# **Environmental Audit Of the Greens Creek Mine**

## **FINAL REPORT**

**SRK Project 1UK005.001**

**March 2009**

**Figure 3: Production Rock Classification System – Comparison of NNP and NP/AP Criteria**

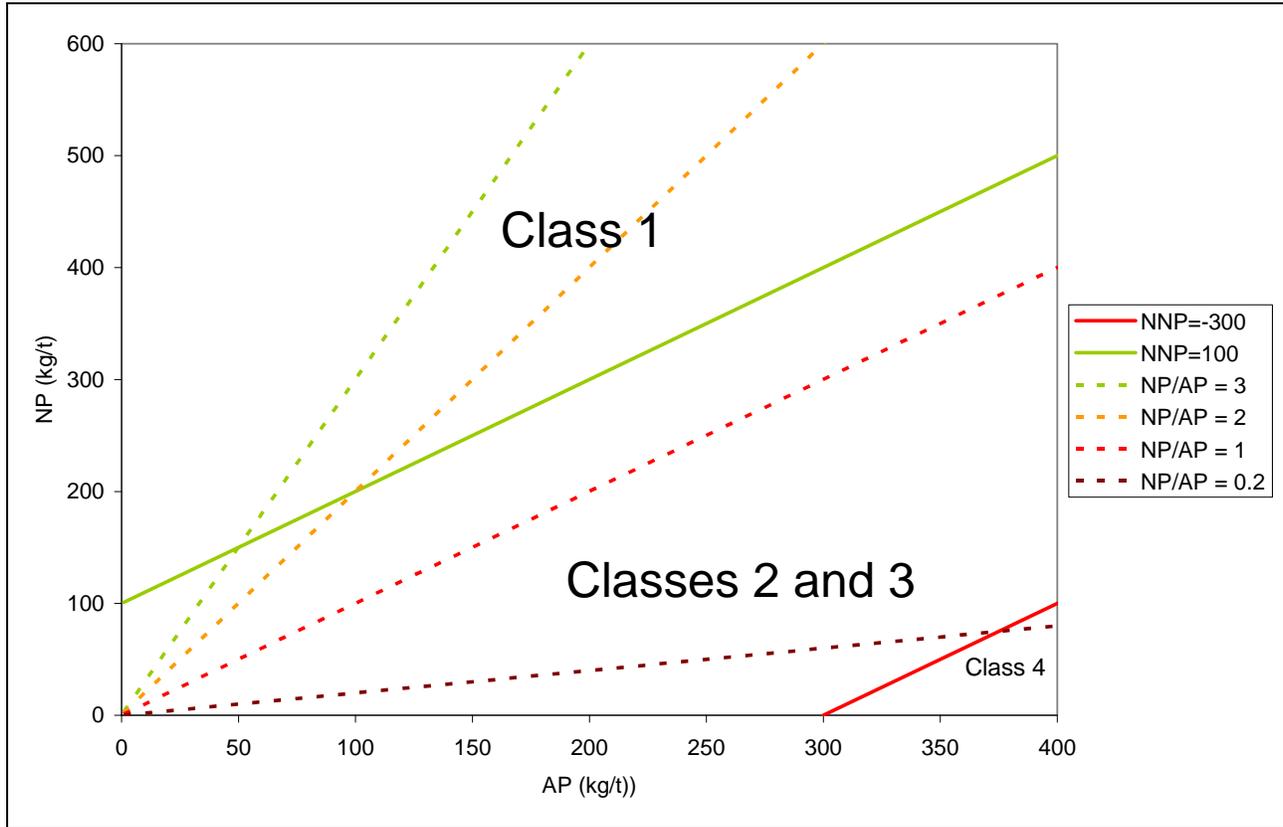
- The geochemical classification system – the NNP-based approach is out-of-date compared to current NP/AP-based approaches (Figure 3). In fact, the original basis for the classification system does not appear to be well established. Class 1 overlaps into NP/APs between 1 and 2, which are usually considered to represent classification uncertainty. However, since most Rock in Class 1 has AP<100 kg CaCO<sub>3</sub>/t, this is not a significant concern. The system is based on ARD potential rather than metal leaching potential. However, modeling by HGCMC has considered leaching of zinc and cadmium from the production rock (see Section 4.2.2.6).
